PROJECT			CLIENT		 DOWSE NORWOOD ARCHITECTS PTY LTD SUITE 10 14 LONSDALE STREET BRADDON ACT 2612 ABN: 43 097 309 325 TEL: 02 6230 4688 FAX: 02 6230 4699	DRAWN	AJ	REVISION
PROPOSED NEW RESIDENCE			UNITED LEGAL			SCALE	1:50 AT A2	CHECKED
BLOCK	SECTION	SUBURB	DRAWING			PROJ NO.	0766	REVIEWED
3	55	KINGSTON	SHADOW DIAGRAMS		DATE	14.11.08	PSP	
					DRAWING NO.	DA-A15	DA	
							BA	
							CONST

DA Number: 200813271
Site Details: Block: 3 Section: 55 KINGSTON
Applicant Name: Glen Dowse

0766- Single Residential-Block 3 Section 55-First Edition Precinct, Kingston

STATEMENT AGAINST RELEVANT CRITERIA

GROUND FLOOR PLAN
SCALE 1:100 @ A2

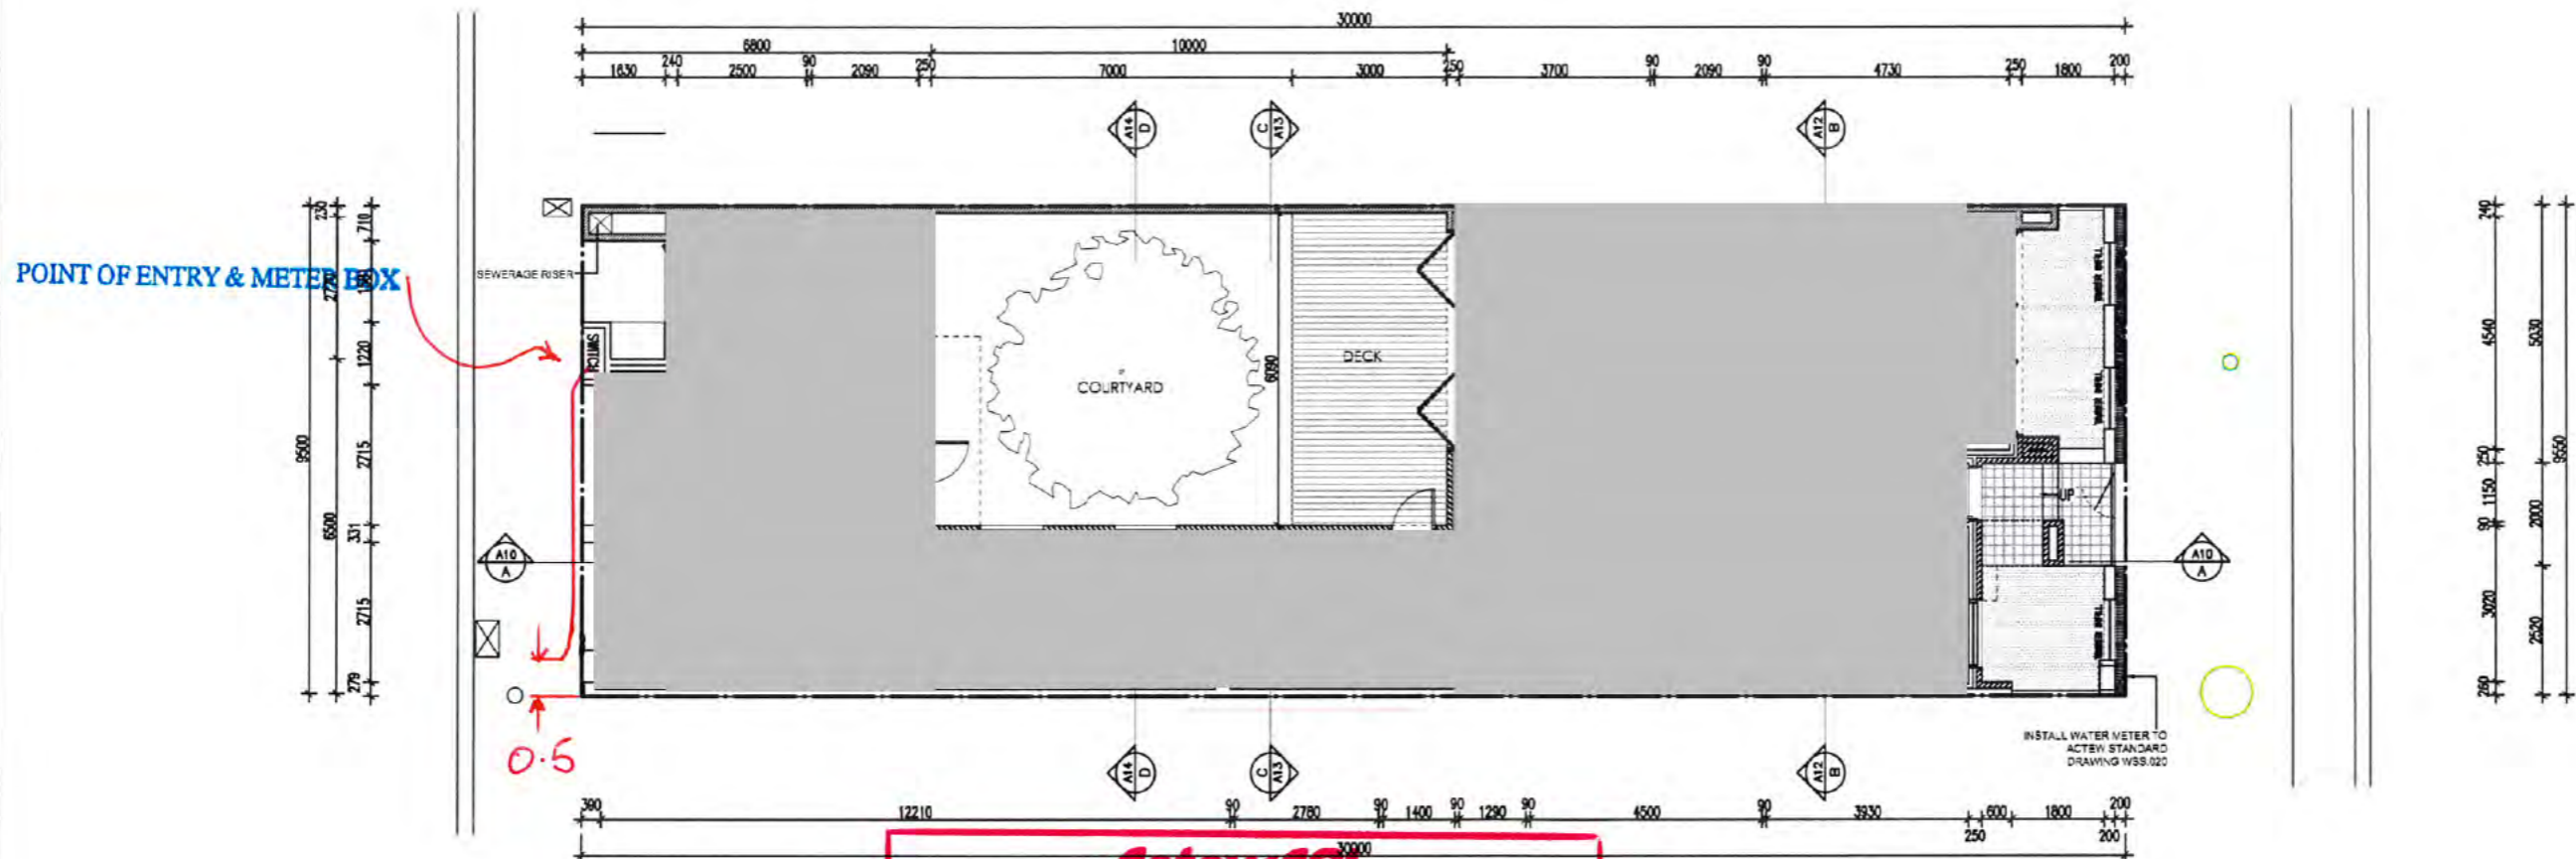
Your re-submitted plans for 3/55 Kingston will be conditionally approved. The conditions will be that the contractor/electrician will have to expose the original conduits, cut and join them with 50mm orange conduit and run it to the new position.

SECOND FLOOR PLAN
SCALE 1:100 @ A2

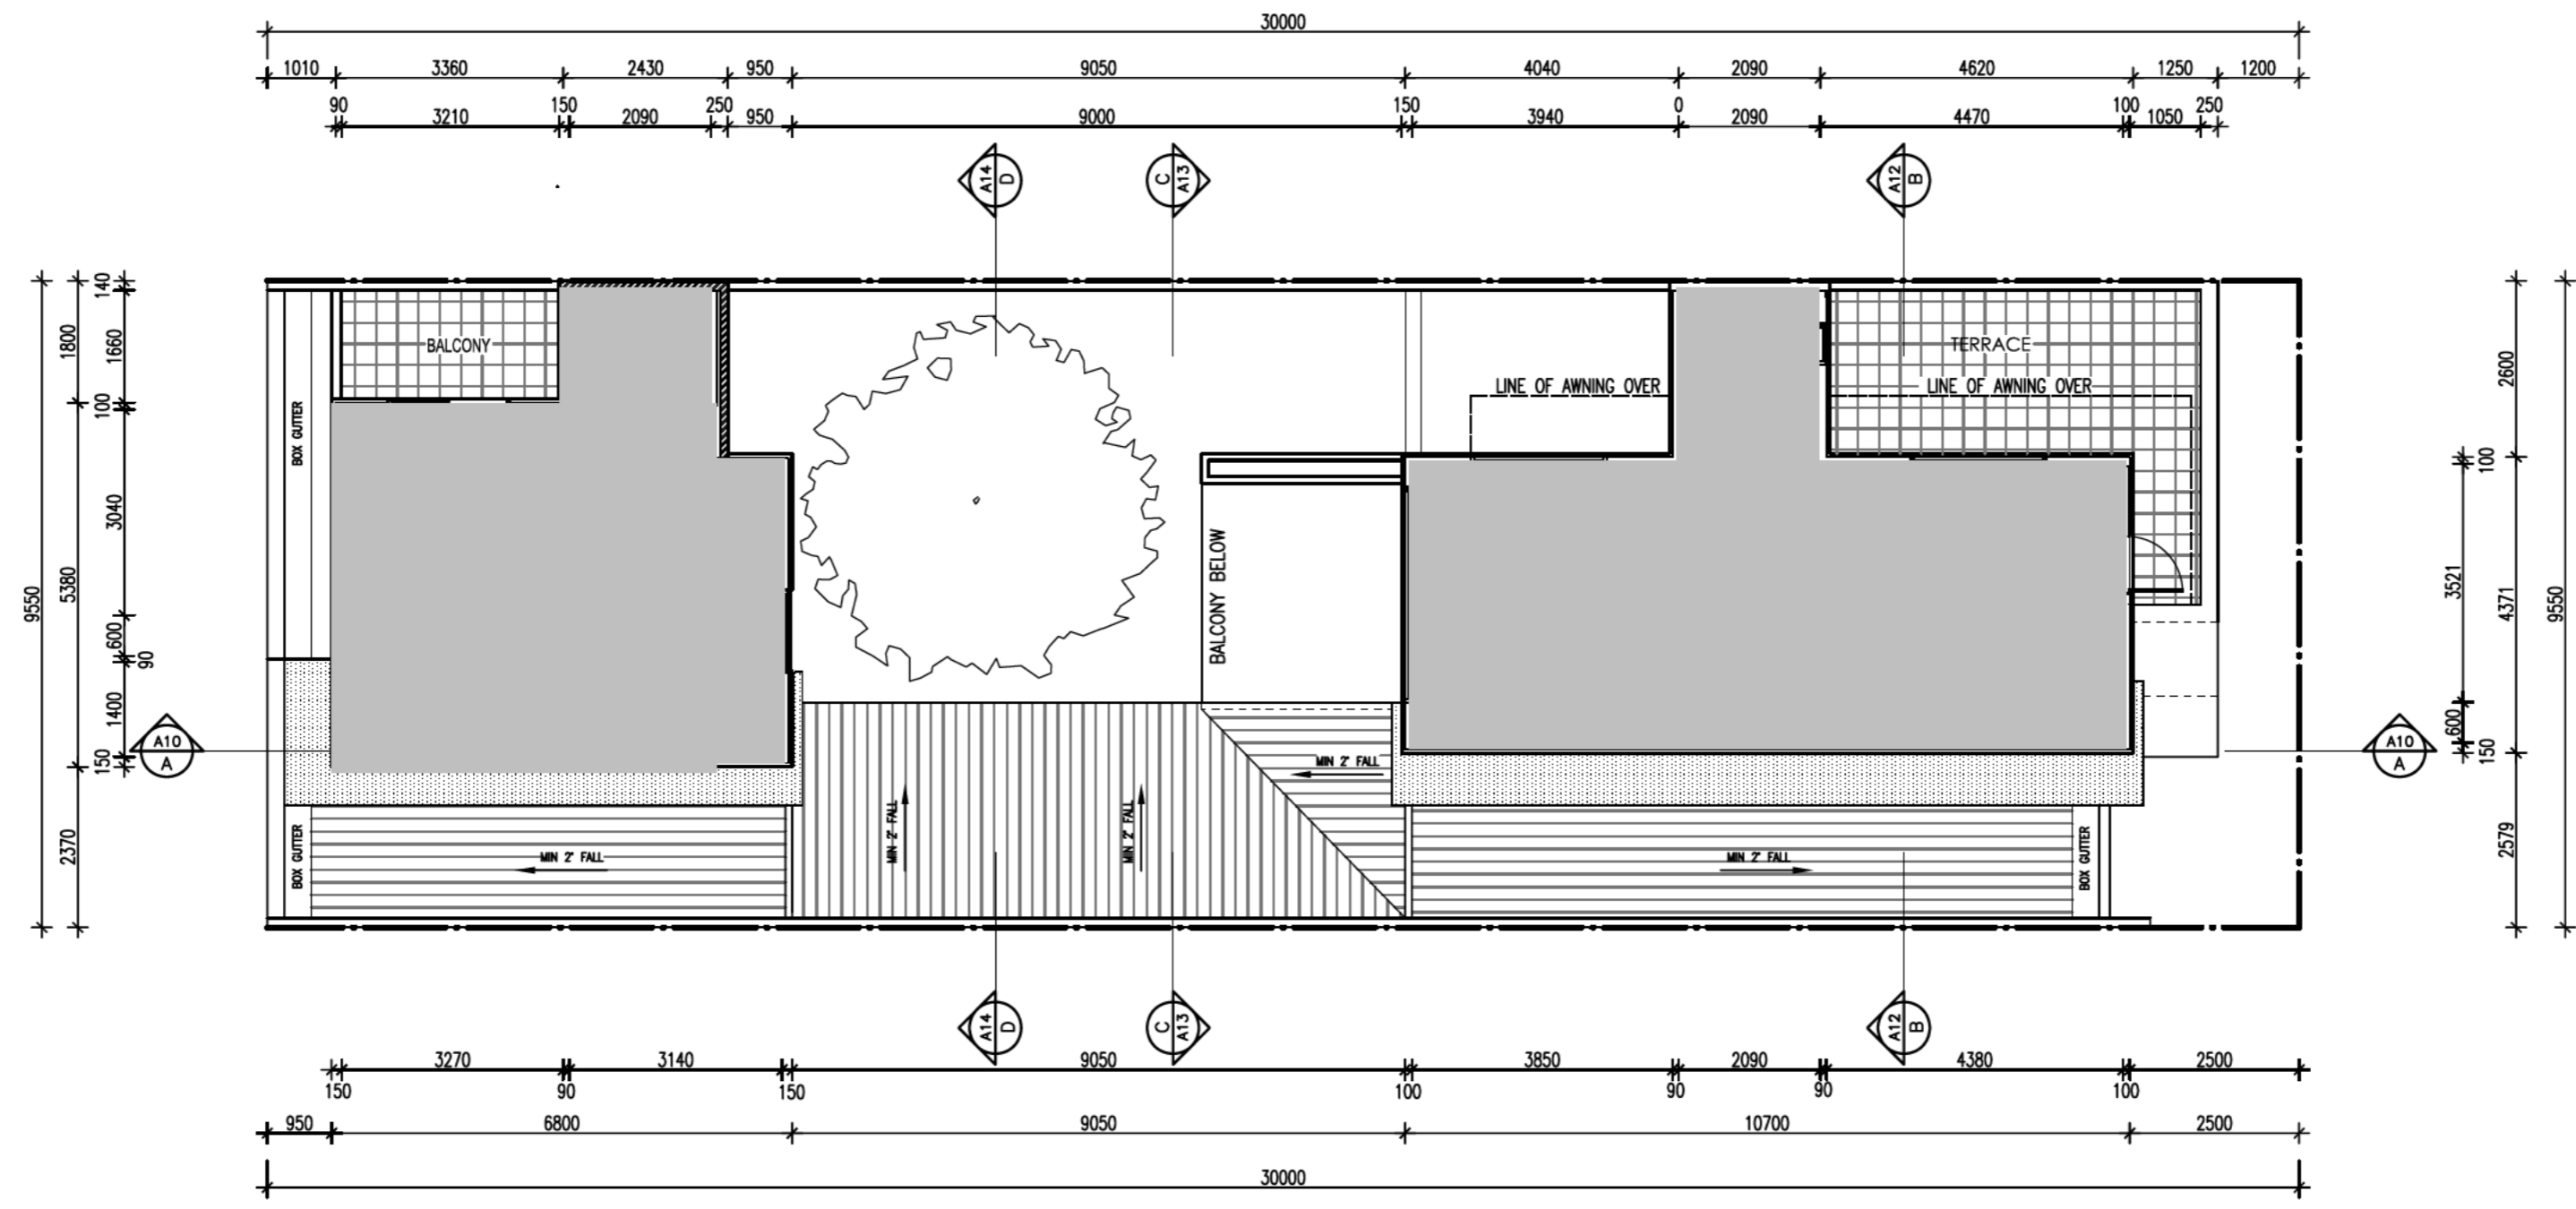
3) The northern third story side building setback is achieved, however the timber cladded stairwell encroaches on to the 1.80m setback. Please provide a statement against criteria addressing this.

- a) The timber clad stairways do encroach slightly into the setbacks required for the 3rd storey element. However, the setbacks were designed to improve solar access and privacy to neighbouring properties.

These stairways being on the Northern boundary only overshadow onto Block 3, not any of the neighbouring sites. The stairways also have no windows that overlook into adjoining properties. Therefore the minor encroachment of the stairways does not adversely affect the streetscape nor the privacy or solar access of the neighbours.
